Blair Creek Stream Mitigation Project

Year 1 (2022) Monitoring Report FINAL

Response to DMS Comments (January 19, 2023) for DRAFT Monitoring Year 1 Report.
Blair Creek Stream Mitigation Project, Clay County
Hiwassee River Basin: 06020002
DMS Project #100047 DEQ Contract #7415

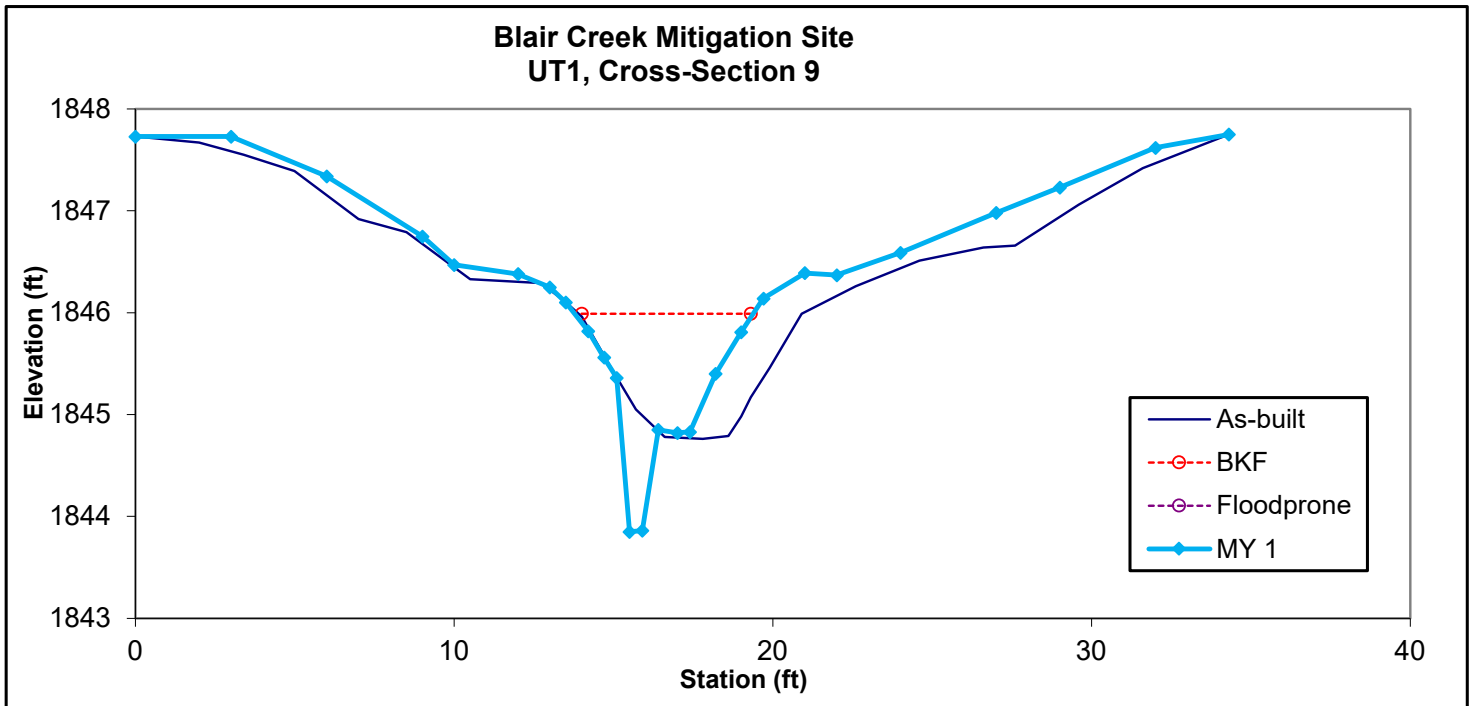
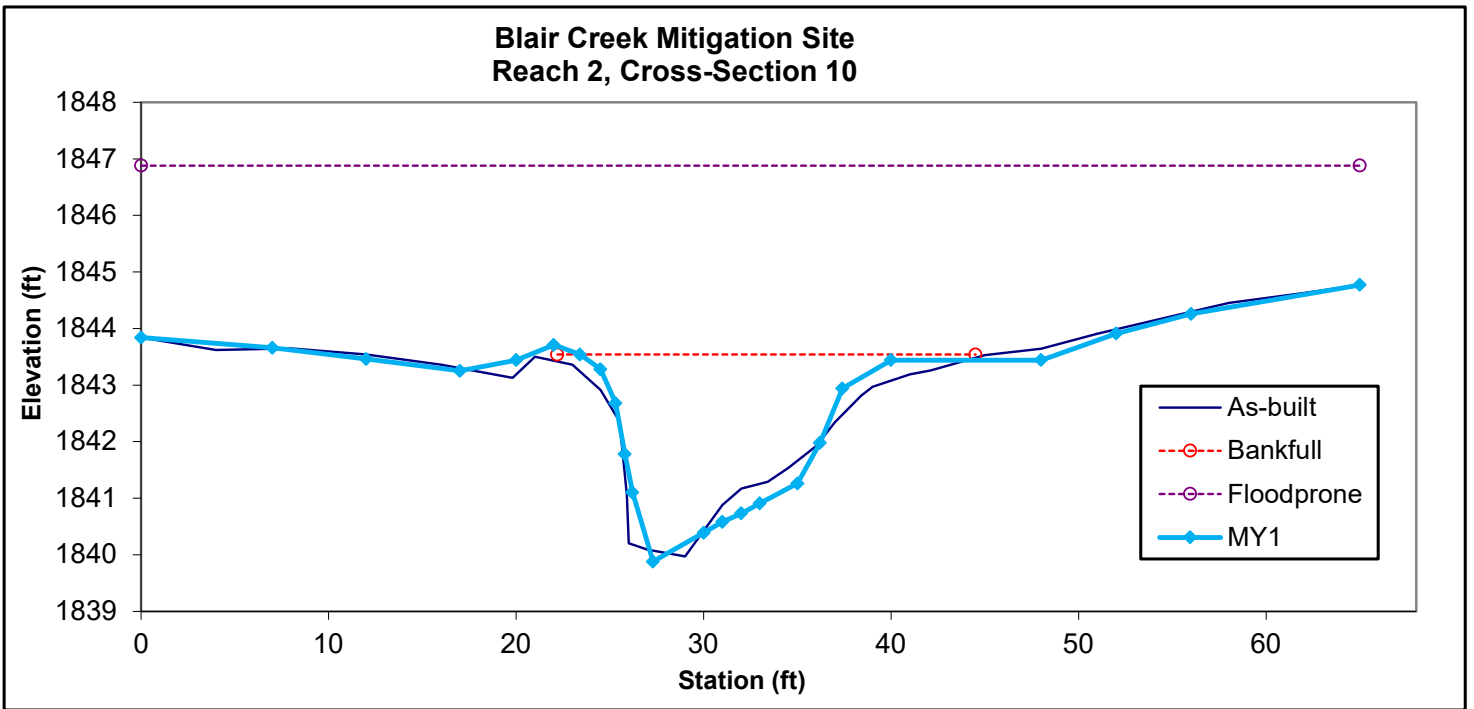
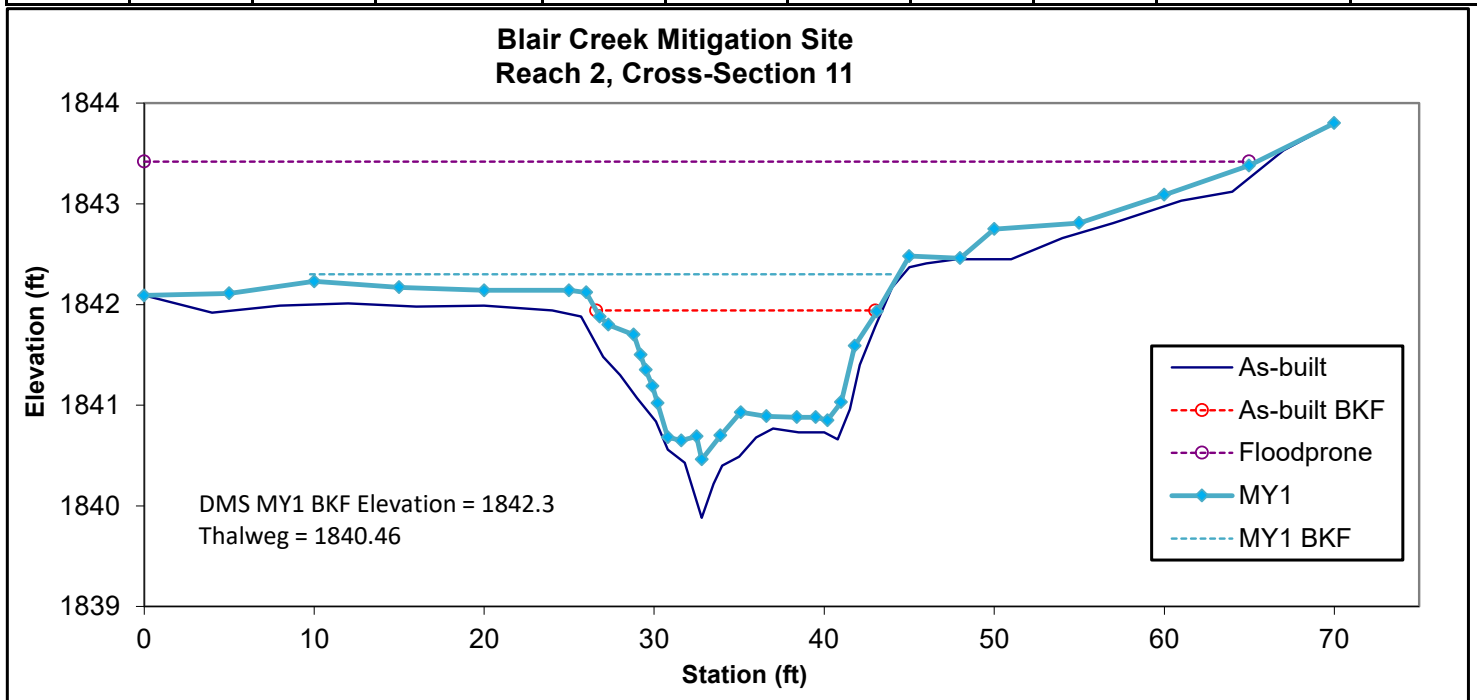
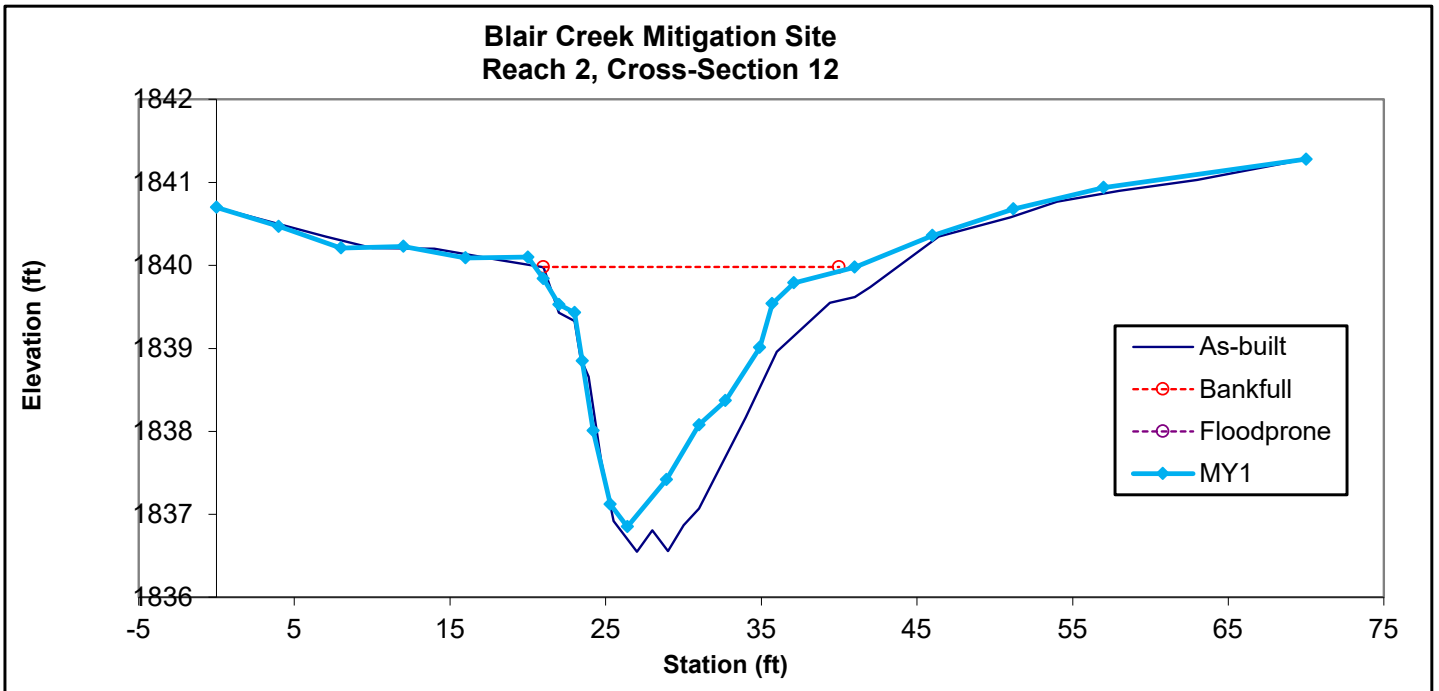
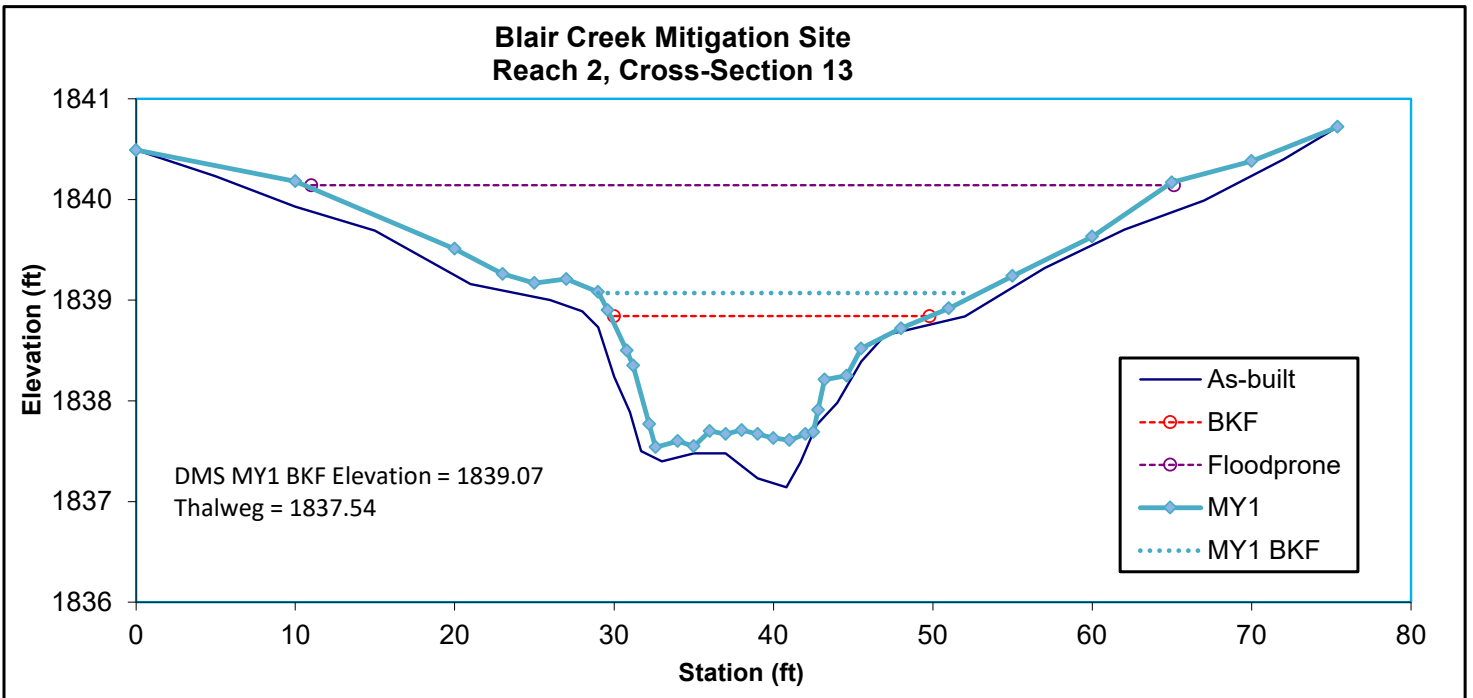
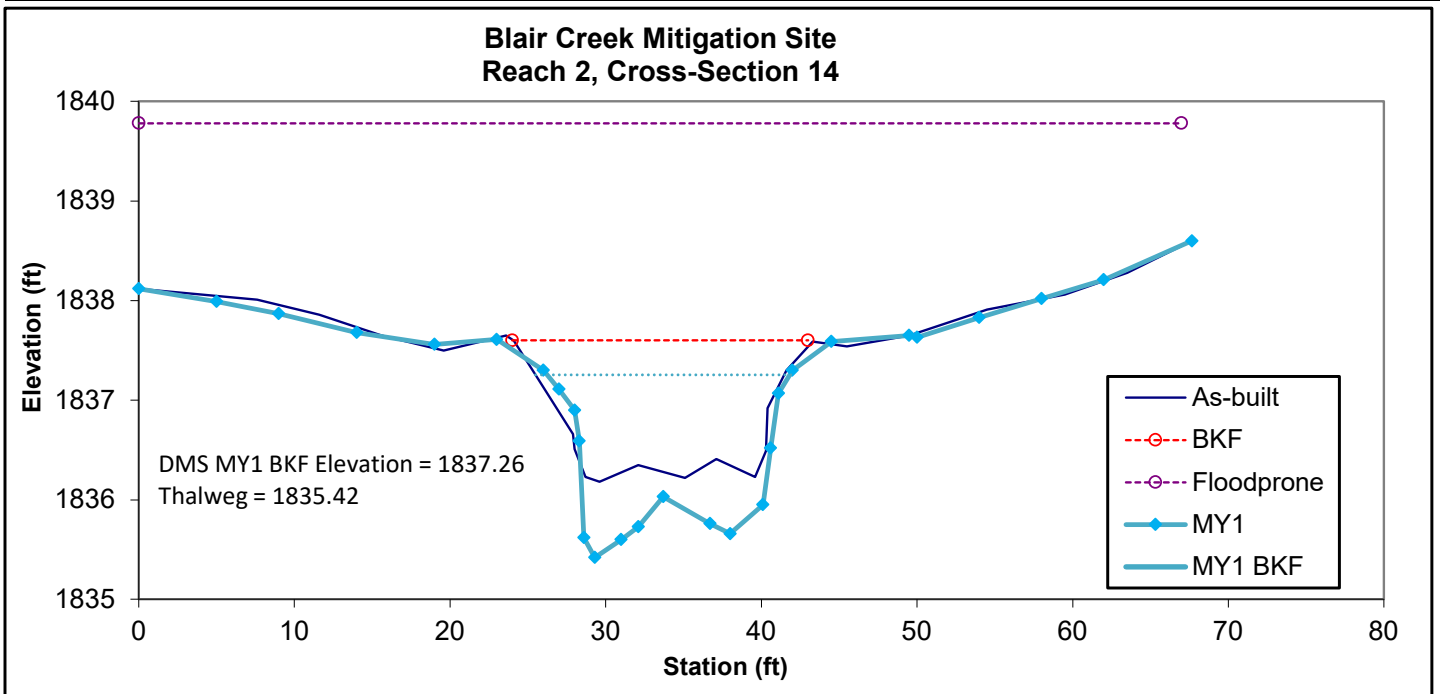
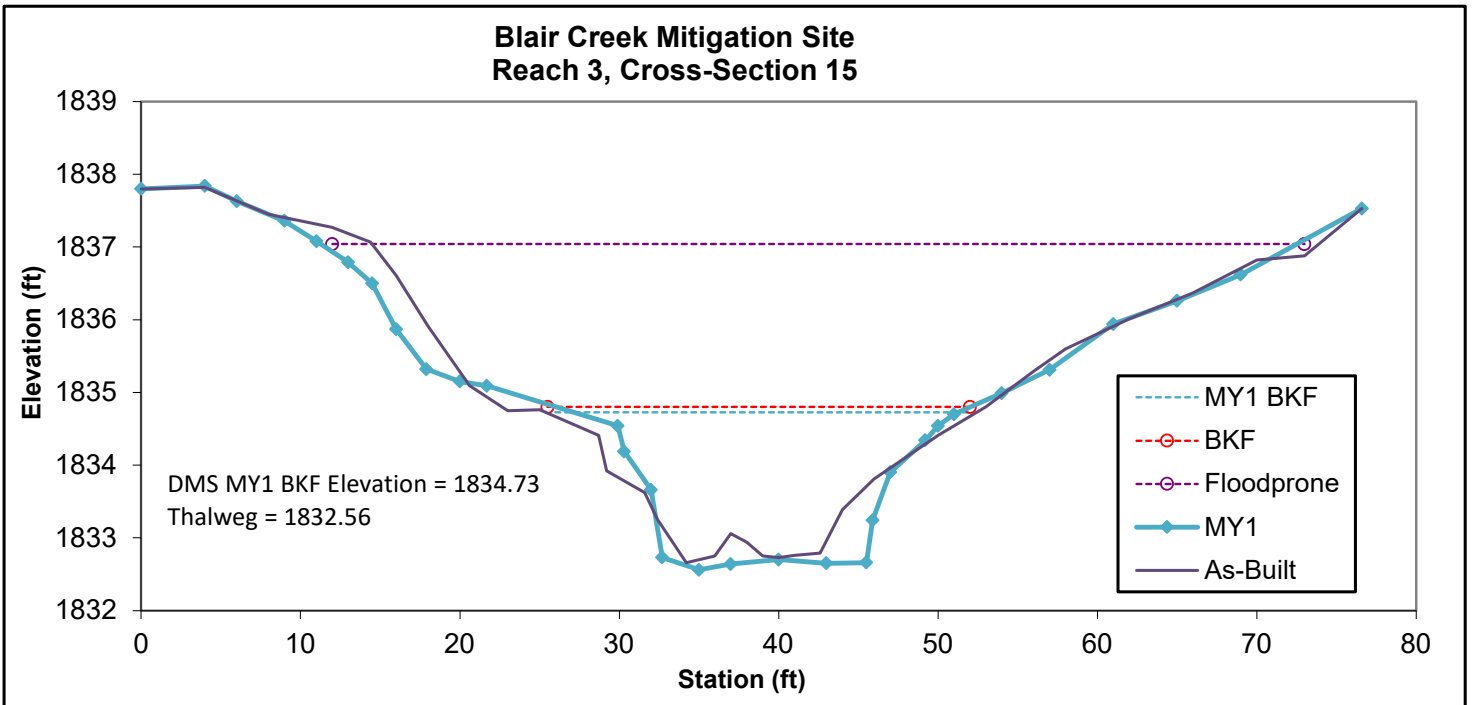
- Cross-section Graphs: Several of the cross-section graphs do not provide confidence that surveys were conducted correctly. Surveys do not begin and end on cross section pins, elevations are different at end pins, and elevation/lateral errors appear to be present in several sections. Please review all cross-sections and specifically XS9-XS14.

RESPONSE: Rebar pins are set at the existing ground elevation and are represented by the first (Left Pin) and last (Right Pin) point of the stationing. End pin stationing and elevation has been corrected and elevations have been reviewed and verified as requested.
